July 11, 1989
88-44-380-01-132

Subject: INTERIM SOIL SAMPLING REPORT AND RECOMMENDATIONS
2724 Castro Valley Blvd.
Castro Valley, California

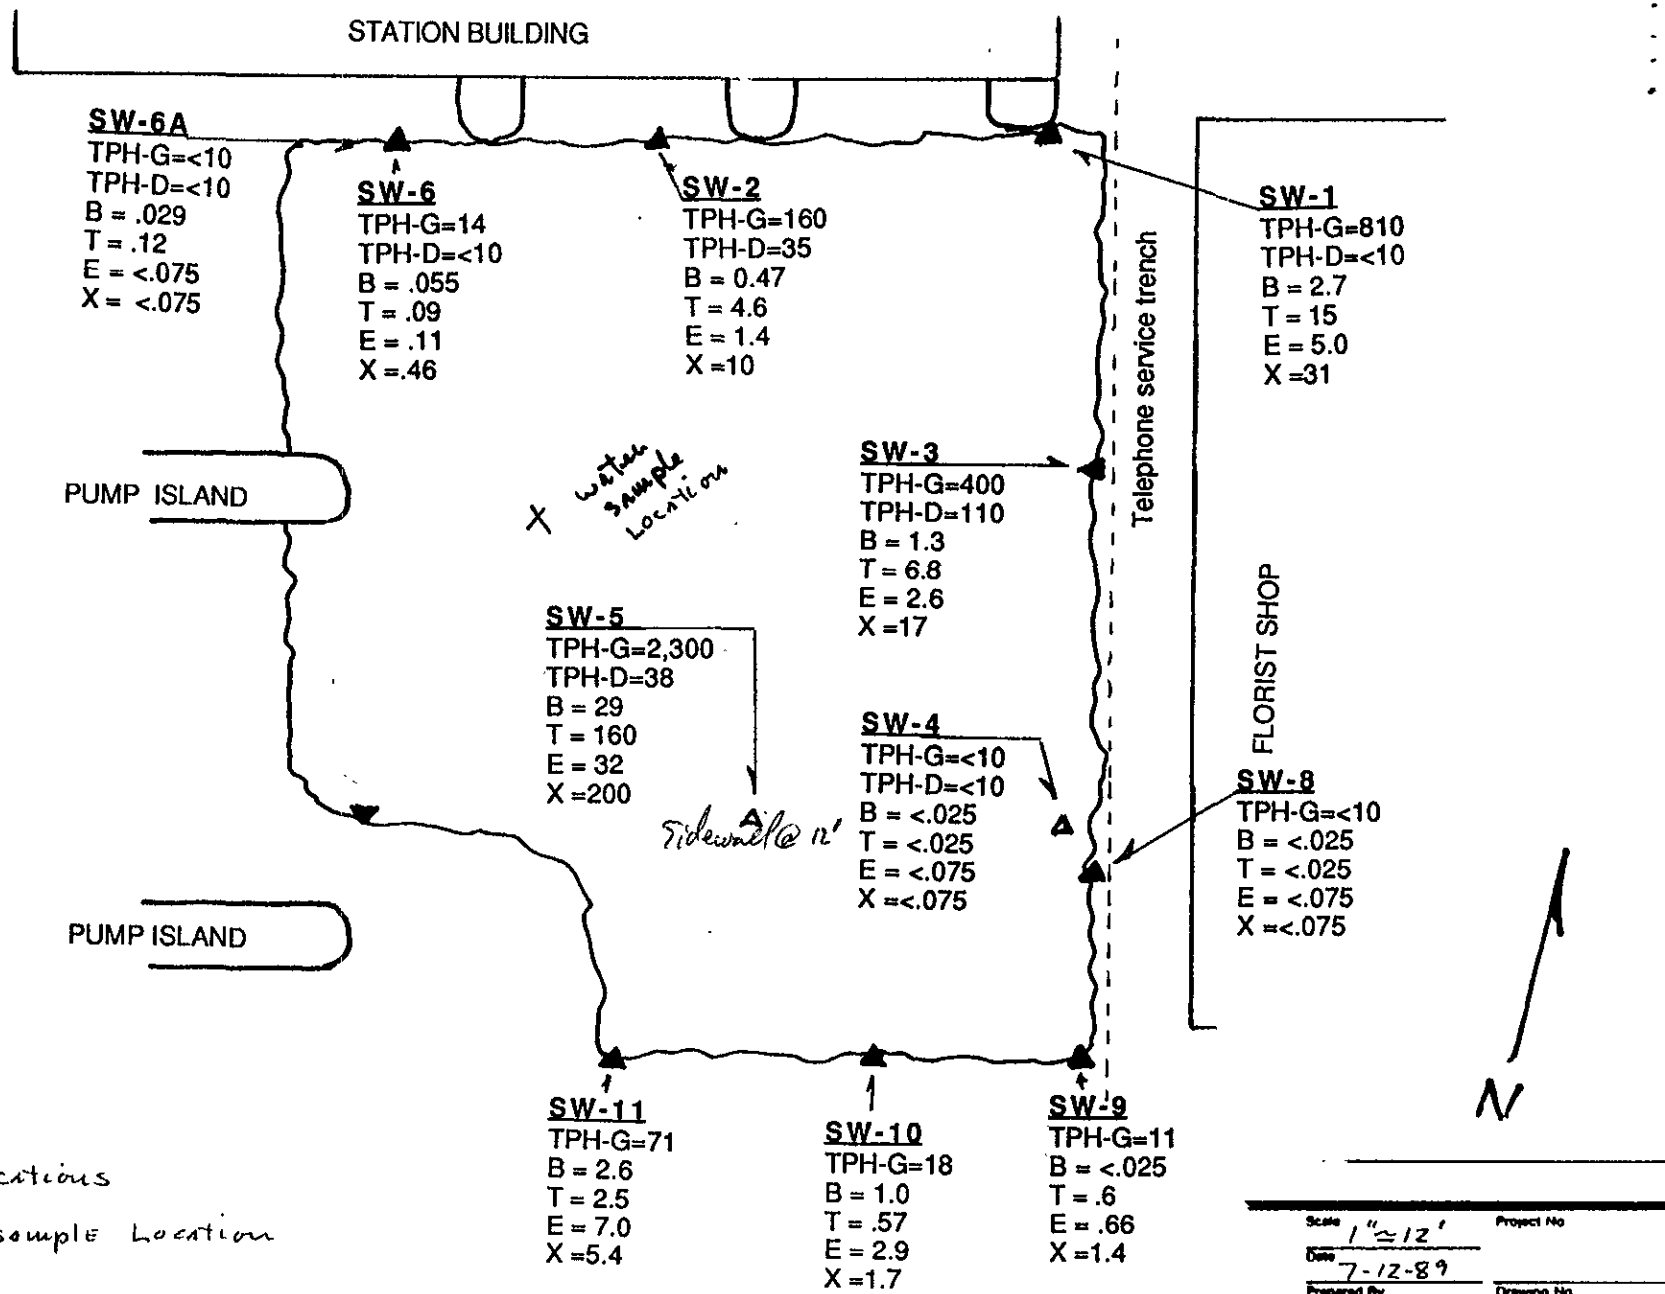
*Removed to
where?*
